DART SERVICE INSTRUCTION

TO AMEND INSTALLATION INSTRUCTIONS D350-567 REV. E
AND INSTRUCTIONS FOR CONTINUED AIRWORTHINESS ICA-D350-567 REV. 2

REF. TCCA STC: SH92-18

A	NEW ISSUE (SEE PAR 16-510)	AJS	16.04.06
REV.	DESCRIPTION	BY	DATE
DESIGN	AJS	DART AEROSPACE LTD	
DRAWN	AJS	HAWKESBURY, ONTARIO, CANADA	
CHECKED		DRAWING NO.	REV. A
MFG. APPR.	N/A	DSI 9745	SHEET 1 OF 3
APPROVED		TITLE	SCALE
DE APPR.		ALTERNATE FIRE EX LOCATION	NTS
DATE	16.04.06	COPYRIGHT © 2016 BY DART AEROSPACE LTD	
THIS DOCUMENT IS PRIVATE AND CONFIDENTIAL AND IS SUPPLIED ON THE EXPRESS CONDITION THAT IT IS NOT TO BE USED FOR ANY PURPOSE OR COPIED OR COMMUNICATED TO ANY OTHER PERSON WITHOUT WRITTEN PERMISSION FROM DART AEROSPACE LTD.

**DETAIL A**

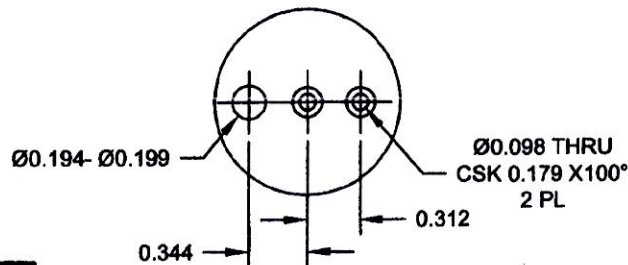
Locate the D5420-1 Doubler Plate at the selected location per Figure 1 and transfer mark the holes from the D5420-1 Doubler Plate to the aircraft floor. Drill the nutplate hole pattern shown in Detail A. Touch up the drilled floor surface finish with chemical film (Alodine 1200/1201) per MIL-C-5541 and one coat of MIL-P-85582 or MIL-P-23377 primer.

FIGURE 1

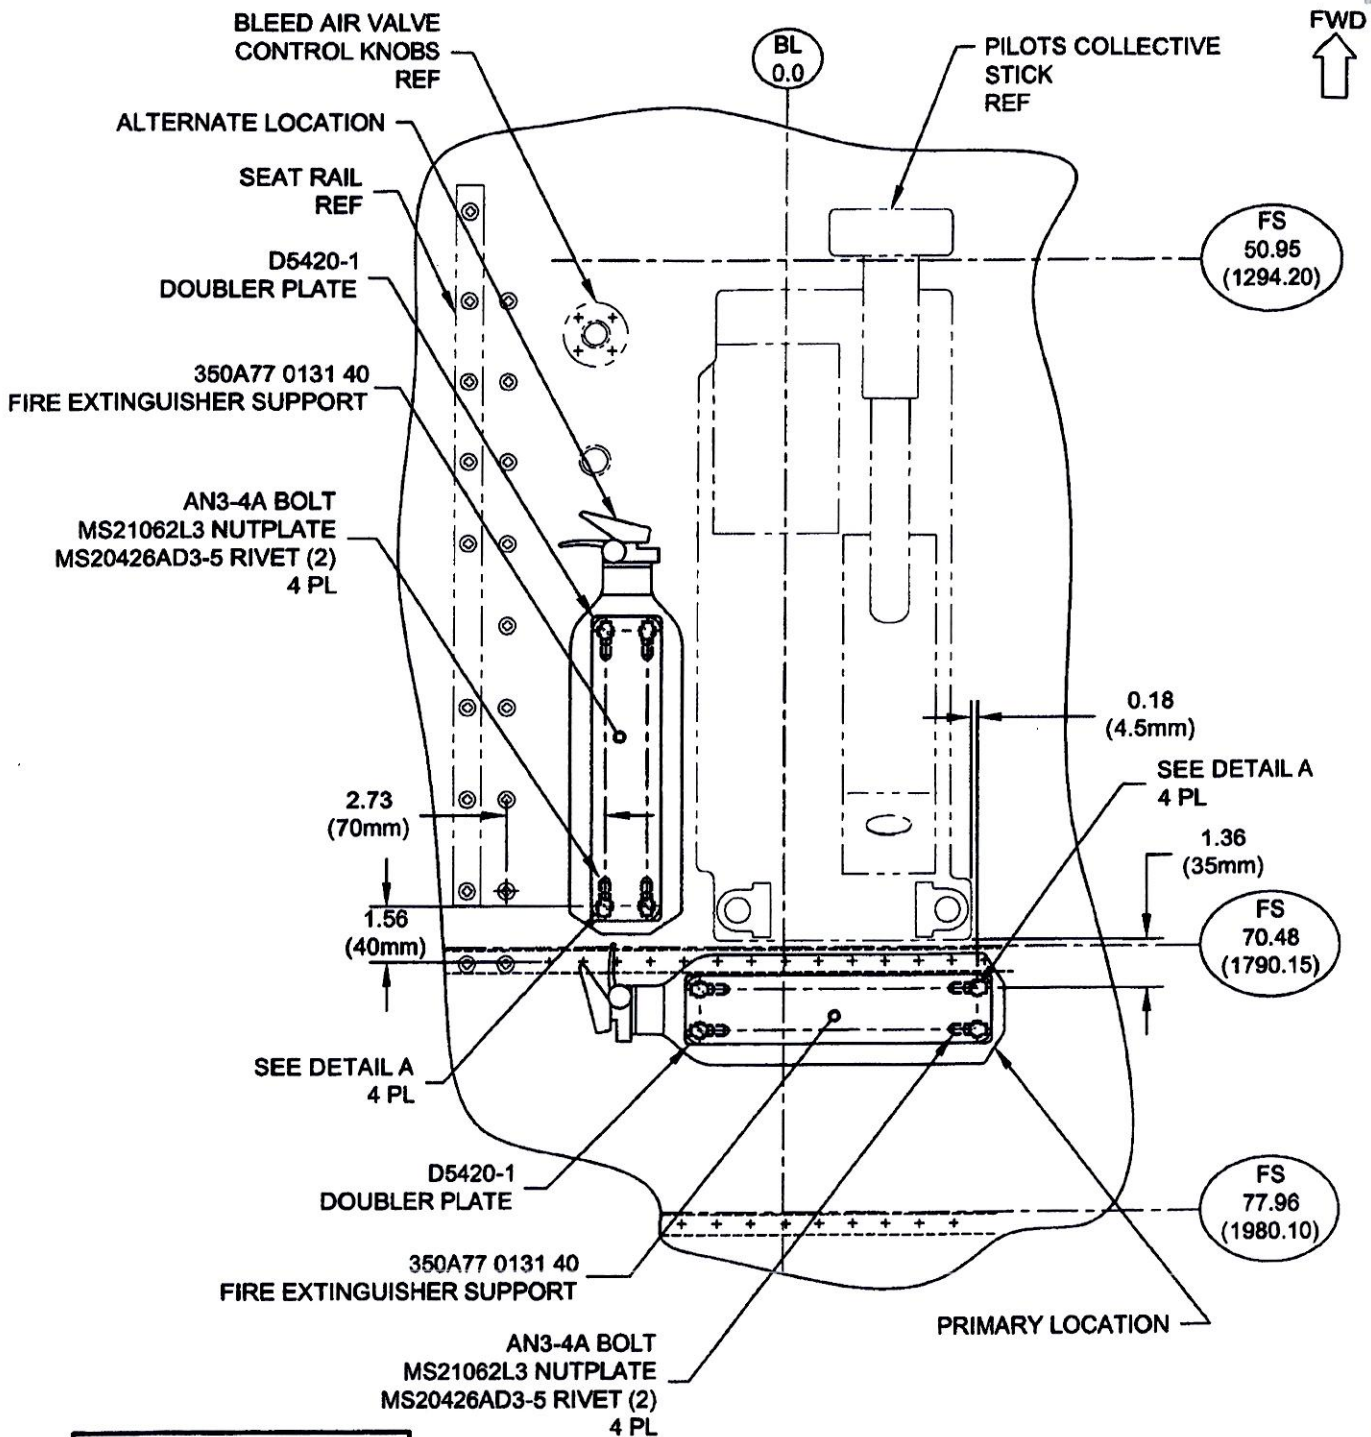
Remove and retain the cabin fire extinguisher P/N 1708337 B4 and Fire Extinguisher Support P/N 350A77 0131 40 from existing location. Per Figure 1, select the desired location for the fire extinguisher at either the "Primary" location or "Alternate" location.
